U. S. NUCLEAR REGULATORY COMMISSION  
OFFICE OF INSPECTION AND ENFORCEMENT

Report No. 50-184/79-05

Facility Name: NBS Reactor

Inspection Summary:

**REACTOR BUILDING SITE**  
ATTACHMENT 1

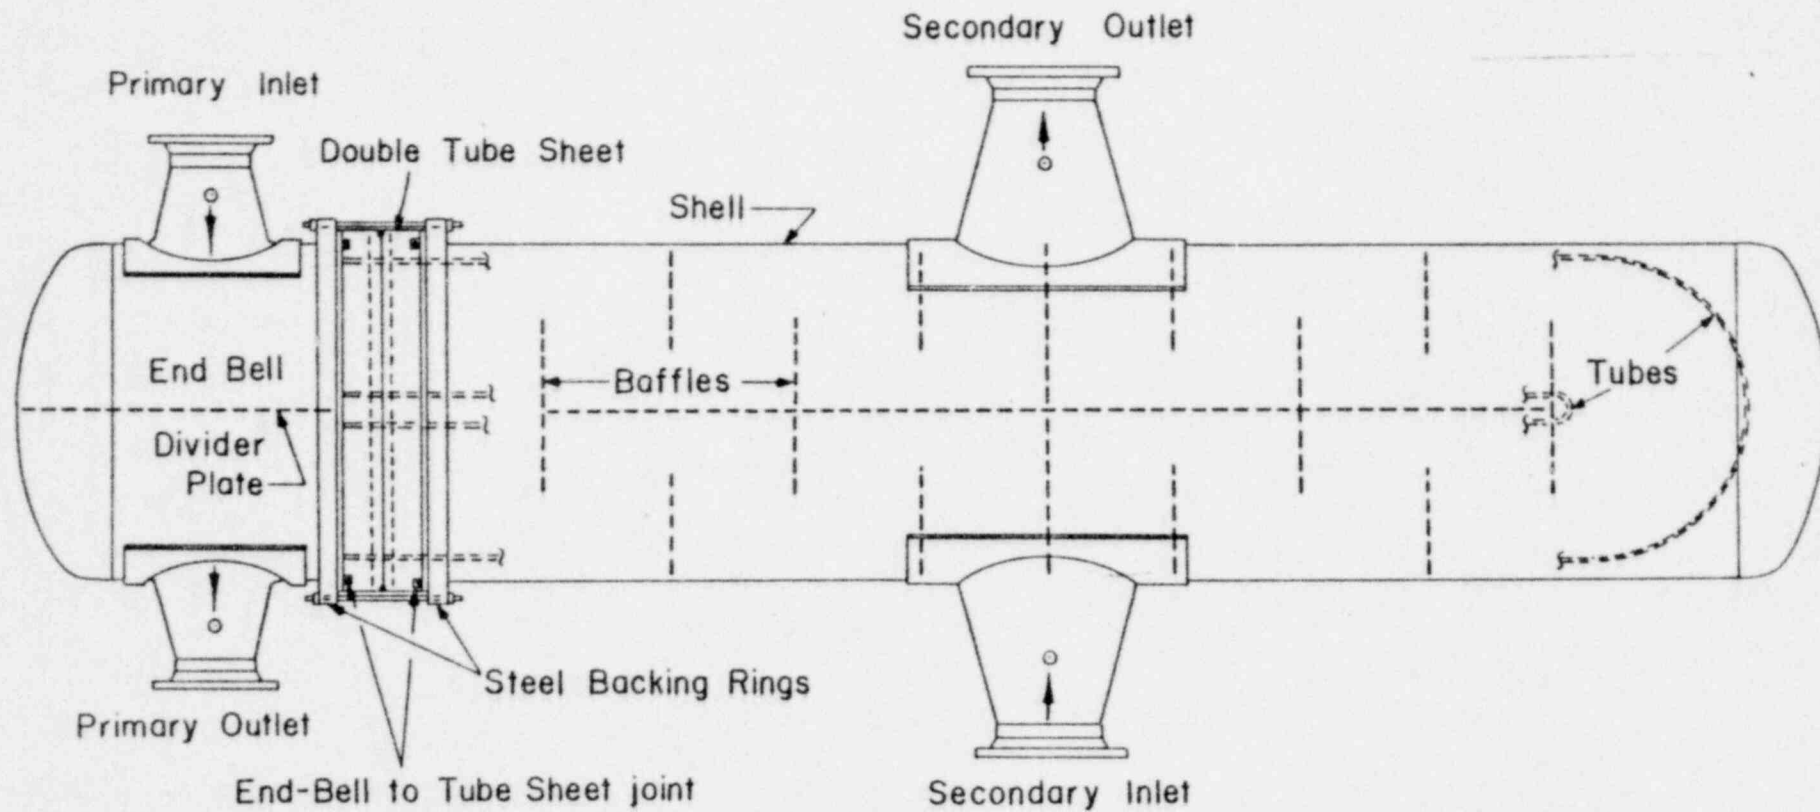
The routine survey was commenced near the reactor building, on August 28, 1979. This identified first some radioactive "hot spots" at places shown as  $G_f$ ,  $G_1 - G_9$ , and x on Attachment 1. Survey on the highest part of the roof identified  $R_s$ . Further survey inside the fenced enclosure, which is a blacktopped area except for concrete structures such as the ramp and the loading docks, identified a general area of contamination near and beneath the heat exchanger, which was known to be internally contaminated. It was unclear whether the areas indicated in Attachment 1 near either end of the heat exchanger were joined or separate. Figures and tables in this report were excerpted, and modified as necessary, from the attached licensee

The inspector and the licensee promptly commenced an urgent non-routine survey effort to identify any other contamination in the environs. Surveys of additional areas on the roof identified R<sub>v</sub> and R<sub>f</sub>. Surveys on the ground identified hot spots at G<sub>v</sub> and V on the south lawn as well as a second location on the front lawn, shown on Attachment 3. Surveys to identify any drainage path of radioactive contamination out through the storm drain identified contamination in the holding basin and at and beyond the outfall, which was greater than 400 feet from the storm drain opening shown on Attachment 1.

The inspector reviewed the NBS drawings of the drainage system. Although part of the drain line for the storm drain shown on Attachment 1 was indicated on the drawing the outfall was off the sheet and there was no indication of how or where the line terminated.

The licensee has prepared sketches such as Attachment 3, for future use, and has a monitoring schedule for this outfall. The outfall is checked at least weekly or after each heavy rain, if more frequent, at this time.
